ADDENDUM NO. 1

Project: NDOT – District 1 Superior St ADA Renovations

Issued: December 22, 2023

SD-1

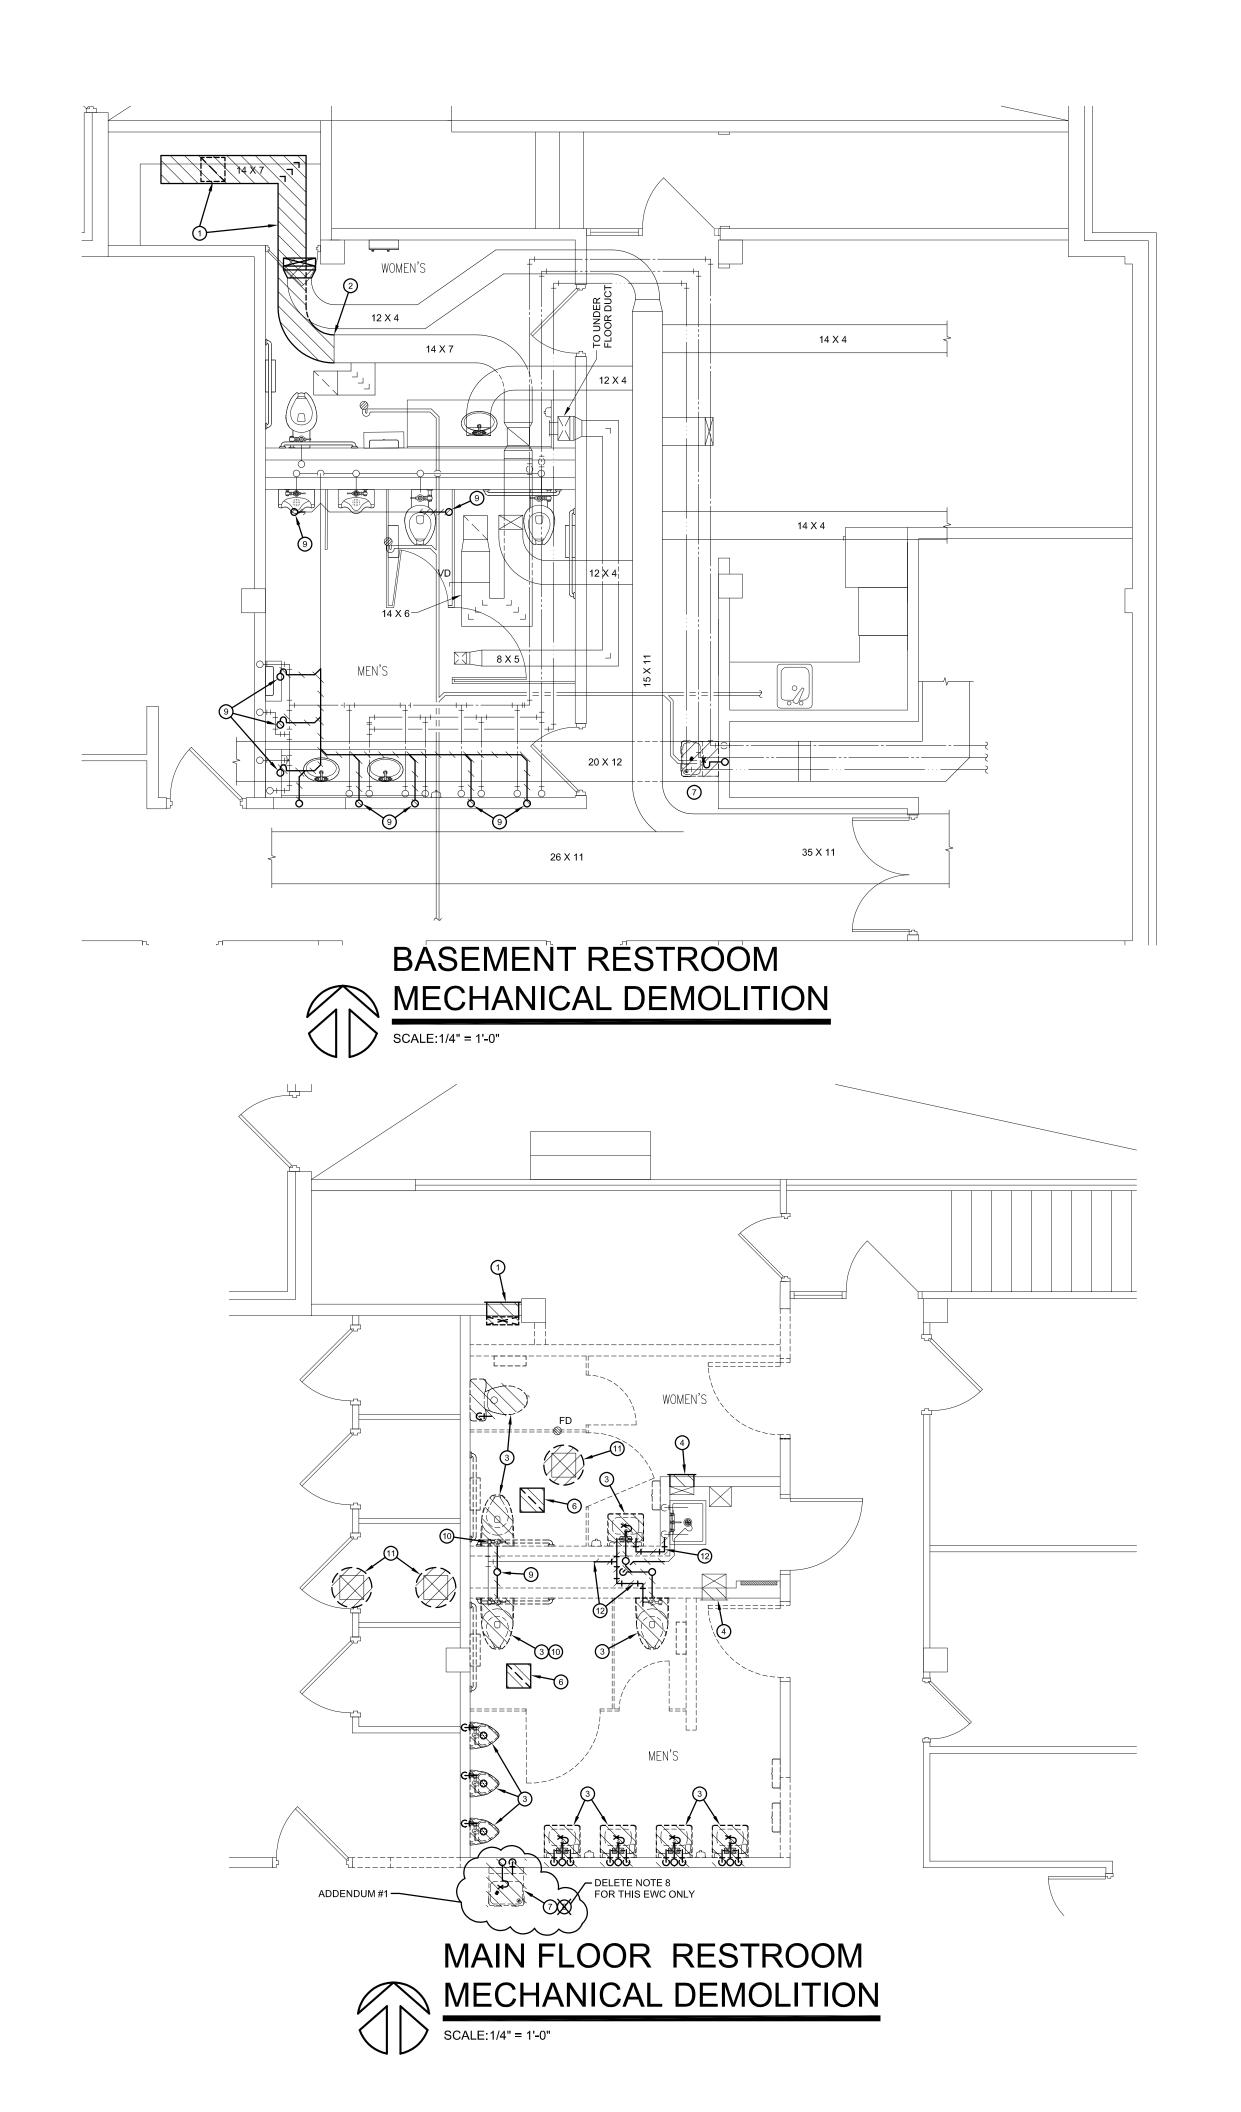
AD1.4. Refer to the attached supplemental drawing SD-1 for location of new semi-

AD1.5. See plan notes and new floor tile pattern on attached SD-1. Floor tile (PT-1) shall

be 12" x 24" in lieu of 36" x 36" originally specified.

M100

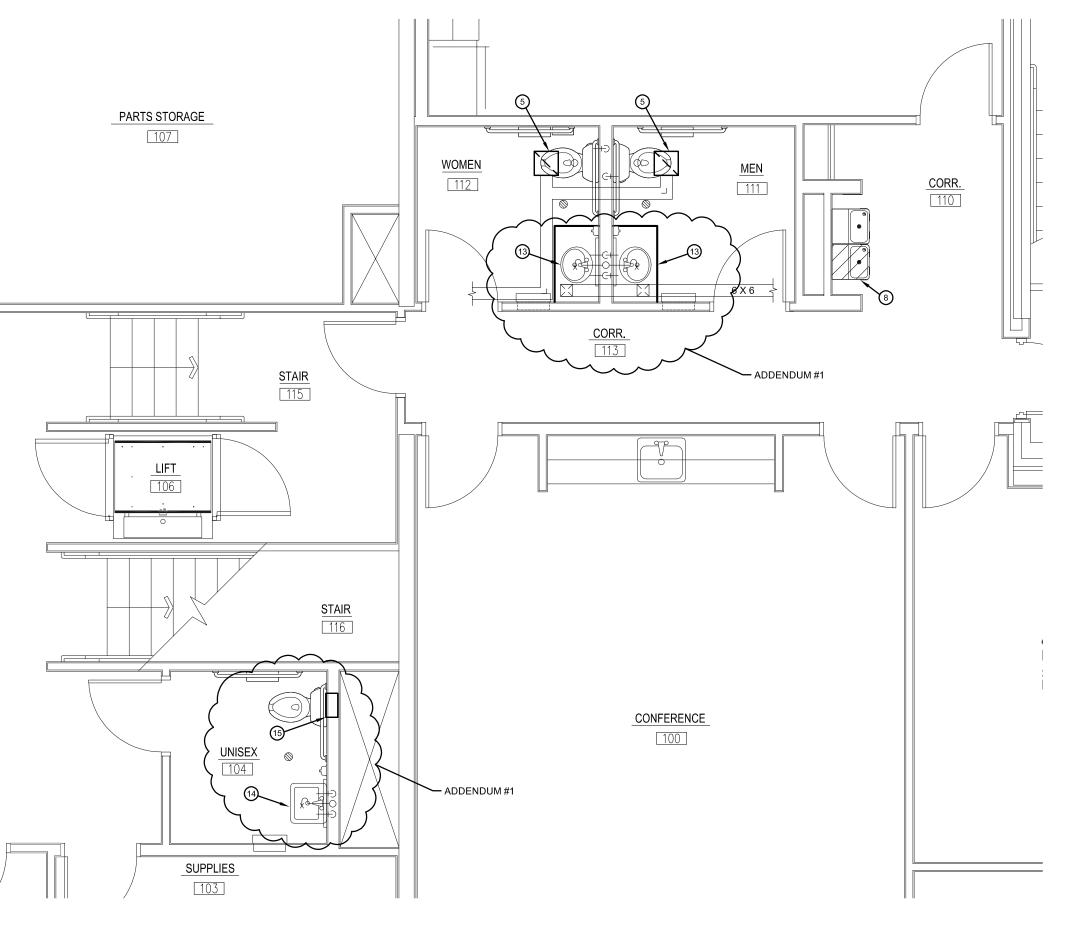
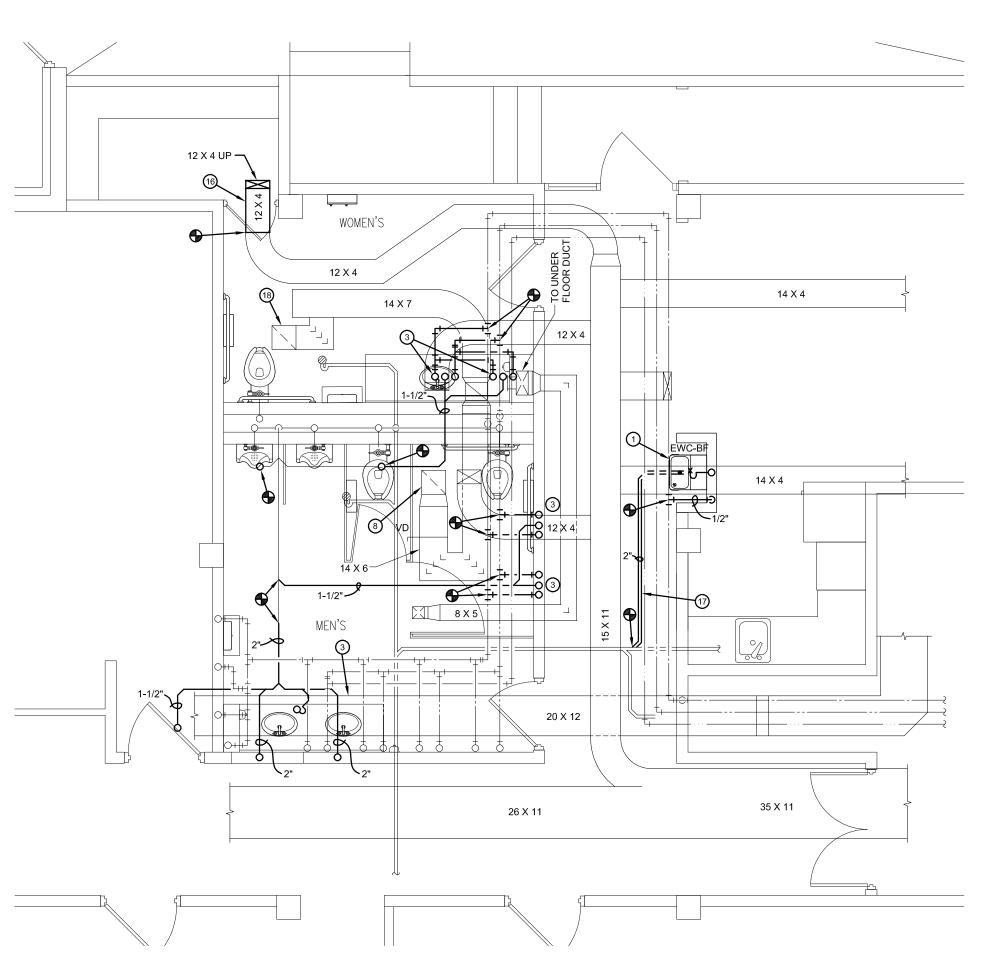
<u>AD1.7.</u> <u>Sheet M100 – Mechanical Demolition:</u> See sheet for additional work requirements.

- 1. REMOVE EXISTING EXHAUST DUCTWORK AND GRILLES AS REQUIRED.
- 2. CAP EXISTING DUCTWORK.
- 3. REMOVE EXISTING PLUMBING FIXTURE. REMOVE WATER, WASTE AND VENT PIPING TO BEHIND FINISHED SURFACES AND CAP AS REQUIRED.
- 4. EXISTING WALL SUPPLY REGISTER TO BE REMOVED.
- 5. REMOVE EXISTING CEILING MOUNTED EXHAUST FAN. EXISTING DUCTWORK TO REMAIN FOR NEW EXHAUST FAN.

M101

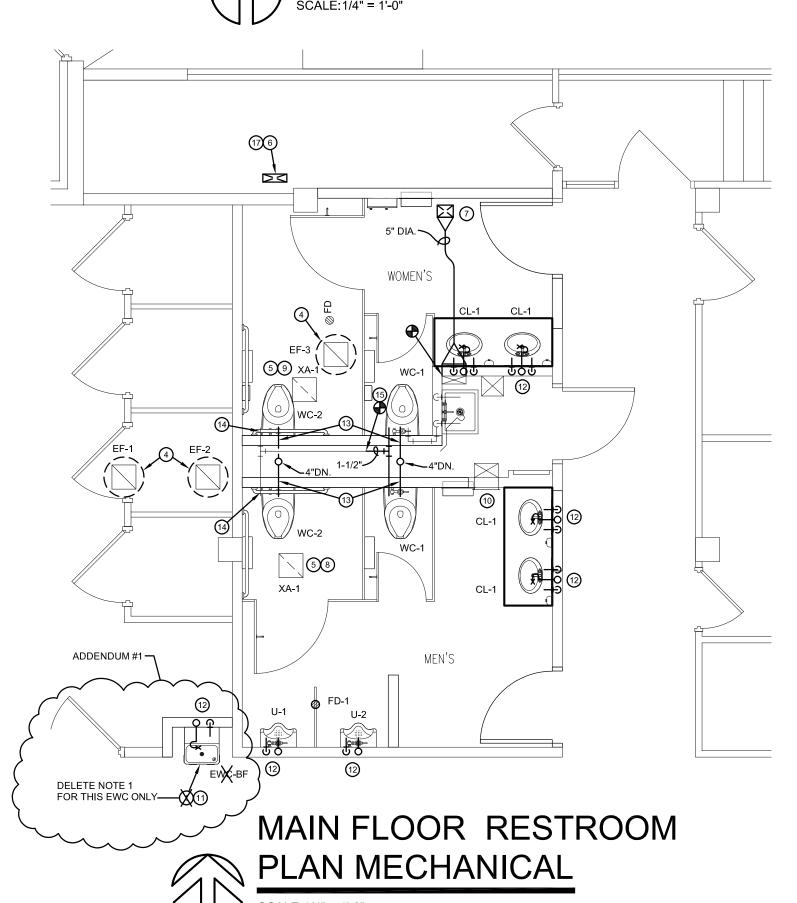
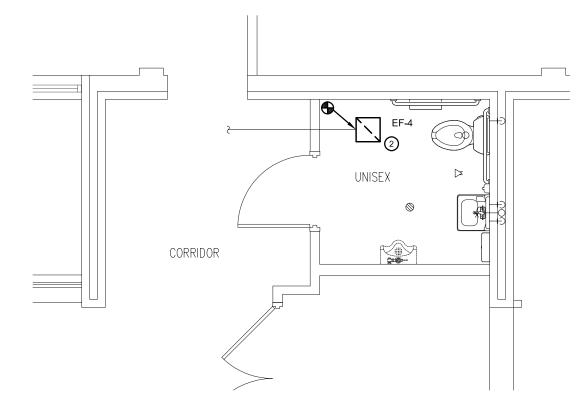
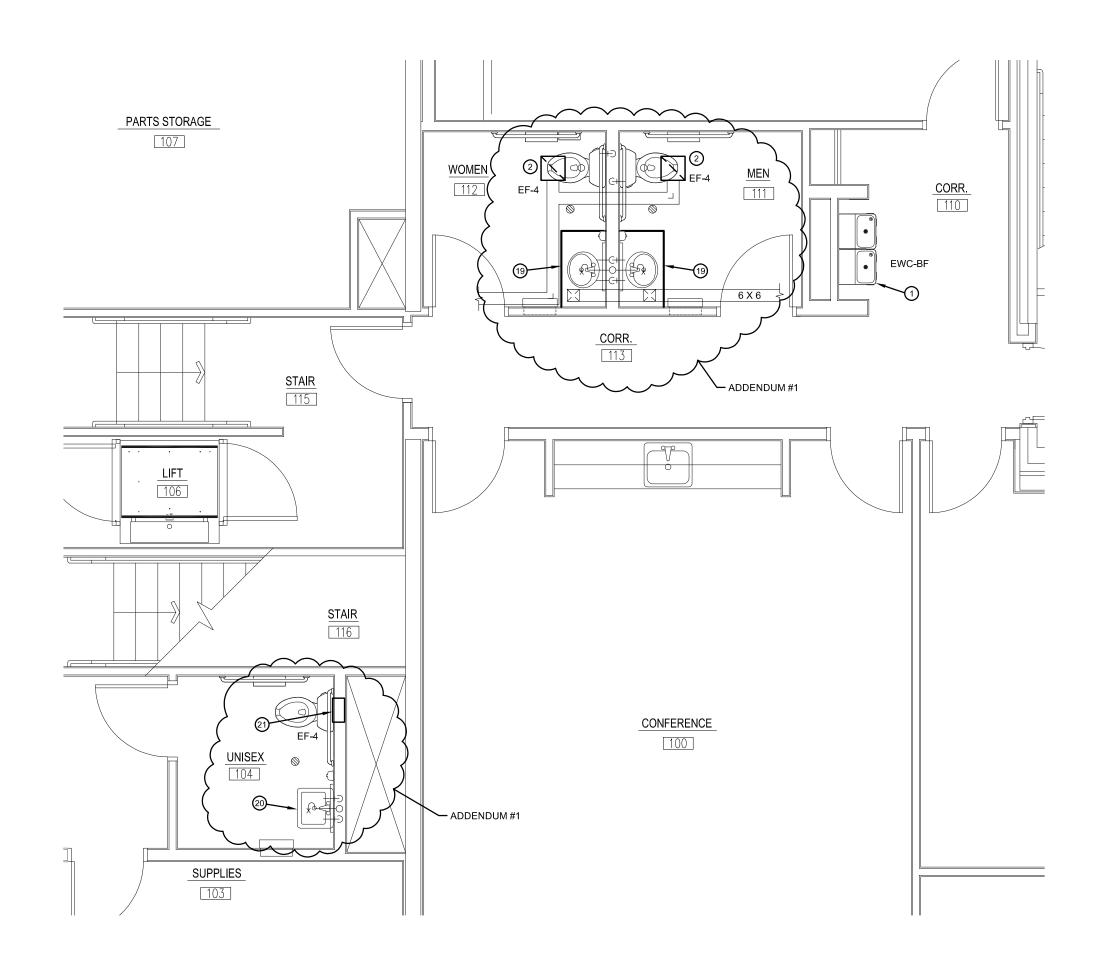
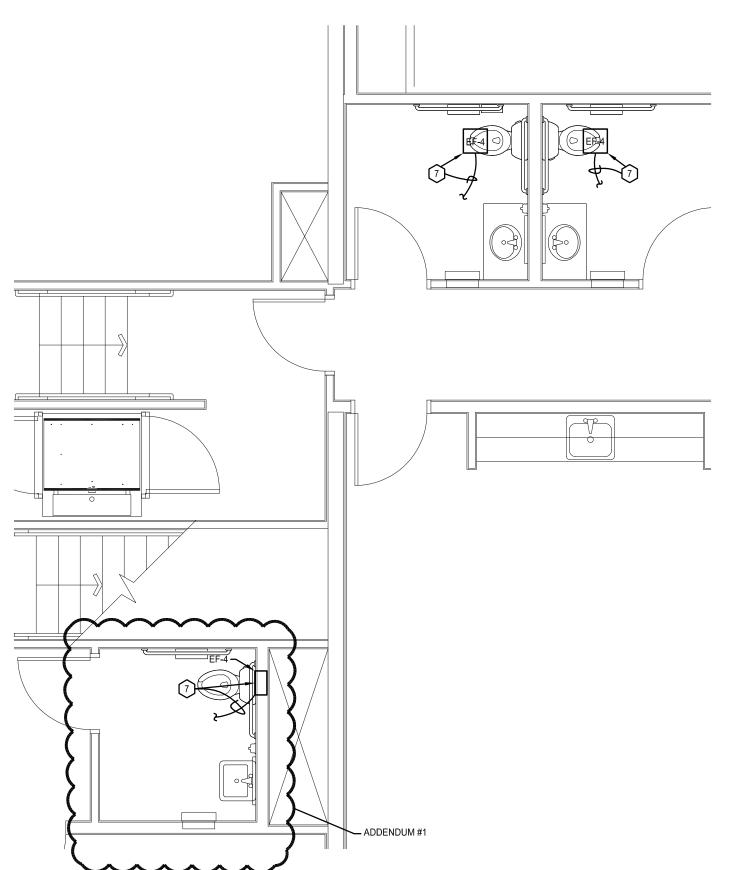
<u>AD1.8.</u> <u>Sheet M101 – Mechanical:</u> See sheet for additional work requirements.

- INSTALL NEW ELKAY RETROFIT BOTTLE FILLING STATION ON EXISTING ELECTRIC WATER COOLER. VERIFY EXACT RETROFIT KIT REQUIRED FOR EACH WATER COOLER BEFORE ORDERING.

- 2. INSTALL NEW EXHAUST FAN IN EXISTING EXHAUST FAN LOCATION.
- EXISTING DUCTWORK LOCATED IN CEILING SPACE. REMOVE AND REINSTALL EXISTING DUCTWORK AS REQUIRED TO INSTALL NEW WASTE AND WATER PIPING.

- 4. INSTALL NEW EXHAUST FANS ON ROOF. EXISTING ROOF CURB TO REMAIN FOR NEW CURB ADAPTER. CONTRACTOR TO VERIFY EXACT DIMENSION OF EXISTING ROOF CURB. CONTRACTOR TO VERIFY EACH INDIVIDUAL EXHAUST FAN IS SERVING THE CORRECT RESTROOM PER THE EXHAUST FAN SCHEDULE.

E100

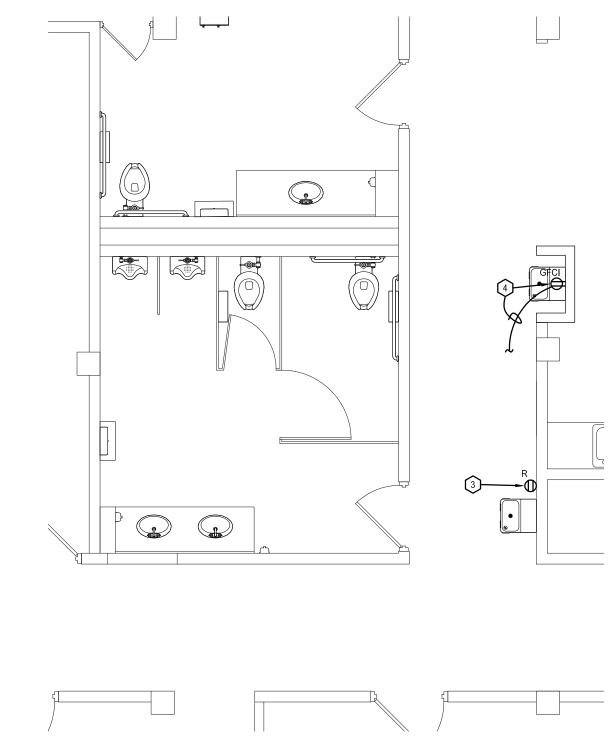
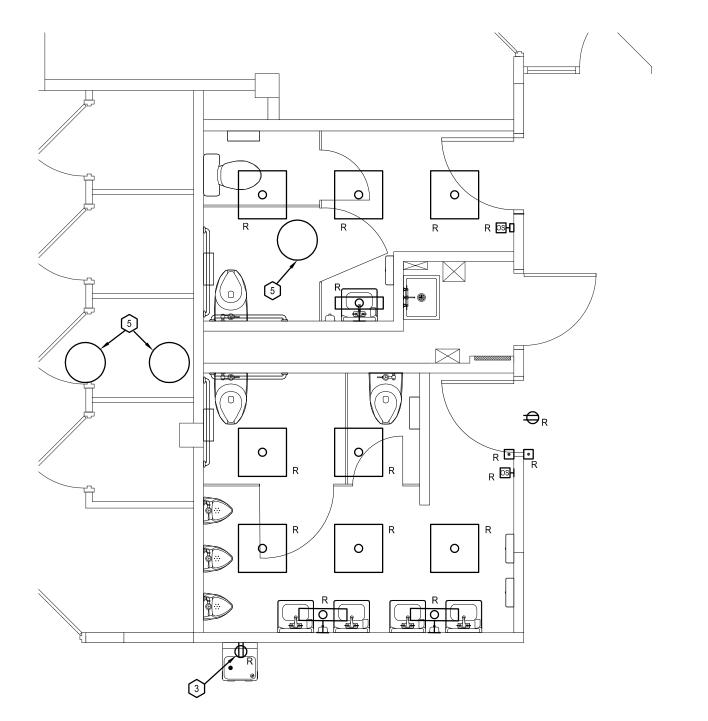
<u>AD1.9.</u> <u>Sheet E100 – Lighting and Electrical Plan:</u> Additional exhaust fan shown to be

replaced.

- 1. CONNECT TO NEAREST AVAILABLE RECEPTACLE CIRCUIT. FIELD
- 2. CONNECT TO EXISTING LIGHTING CIRCUIT IN THIS ROOM.
- 3. REMOVE EXISTING RECEPTACLE AND EXTEND CIRCUIT TO NEW WATER COOLER LOCATION.
- 4. PROVIDE NEW GFCI RECEPTACLE FOR WATER COOLER. MOUNT RECEPTACLE BELOW ENCLOSURE TO ALLOW ACCESS TO RECEPTACLE. COORDINATE WITH PLUMBING CONTRACTOR. EXTEND EXISTING WATER COOLER RECEPTACLE CIRCUIT TO NEW LOCATION AND RECONNECT.
- 5. REMOVE CONNECTION TO EXISTING EXHAUST FAN. EXISTING CIRCUIT SHALL BE REUSED.
- 6. EXTEND EXISTING CIRCUIT TO NEW FAN AND RECONNECT. 7. EXISTING EXHAUST FAN SHALL BE REMOVED AND REPLACED. DISCONNECT EXISTING EXHAUST FAN AND RECONNECT TO NEW
